Service Bulletin Number: 3666243-01

Catalyst Muffler for Service Use Only

This Service Bulletin introduces a new service design for the diesel catalyst in the B and C Series diesel engines.

Automotive Engine Dataplate

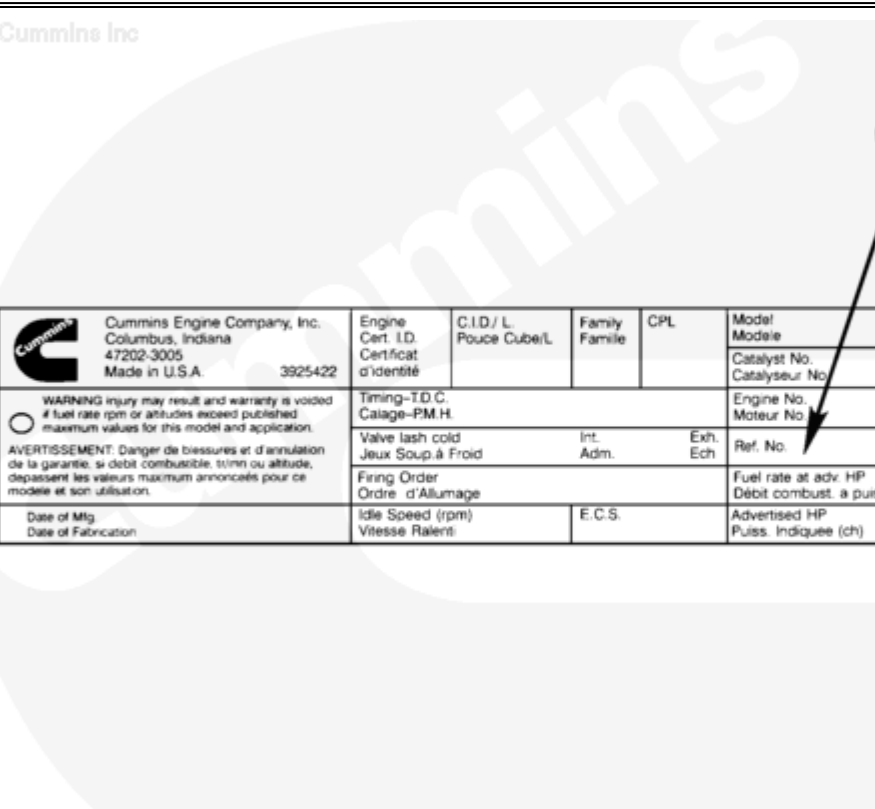
The following configurations are covered by field fix number 226 since they are certified products that are no longer in production. The dataplate **must** be stamped with field fix number 226 (FF226) in the box that reads “Reference Number” (1) whenever a service use **only** catalyst muffler (Part Number 32434) is installed on an engine.
